Model: Model C-C1	Date: 17-Nov-03	No.: MB173001a
-------------------	-----------------	----------------

## MB Correction

Modified Article: Parts catalog correction		Prepared by: T. Shintani	
From: 1st Technical Support Sec. Service Support Dept.			
Reason for Modification:	<input checked="" type="checkbox"/> Parts catalog correction <input type="checkbox"/> To facilitate assembly <input type="checkbox"/> Part standardization	<input type="checkbox"/> Vendor change <input type="checkbox"/> To improve reliability <input type="checkbox"/> Other	<input type="checkbox"/> To meet standards (      )
Modification Schedule:	From first mass production.

**3. When you install the new NCU**

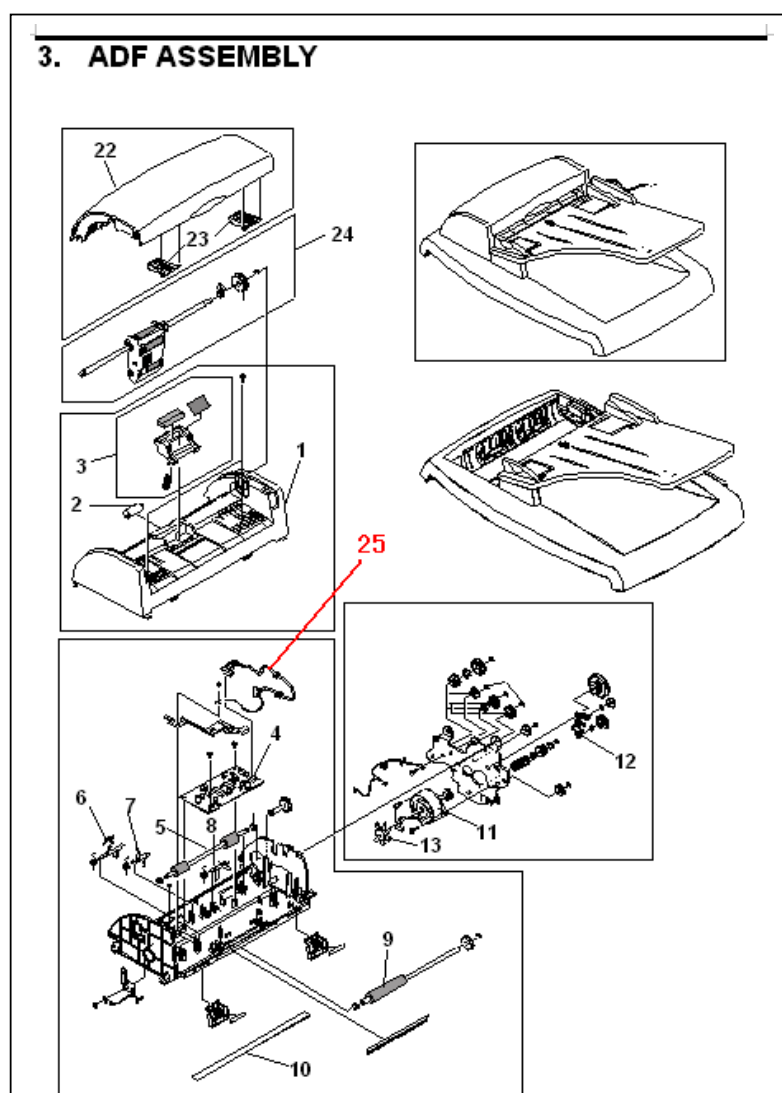
**Change:** Board components were added/deleted.

**Reason:** To make the EU model usable in South Africa.

- 1) If you install the **new** NCU (B1739677), make sure to install firmware **v6.14 or later**.
- 2) When you install v6.14, make sure that the "LIU Select" setting is correct.  
(Tech Mode >> Data Setup >> LUI Setting):

- v6.14 + **New** NCU: Select **"EU&SA LIU"**
- v6.14 + **Old** NCU: Select: **"EU LIU"**
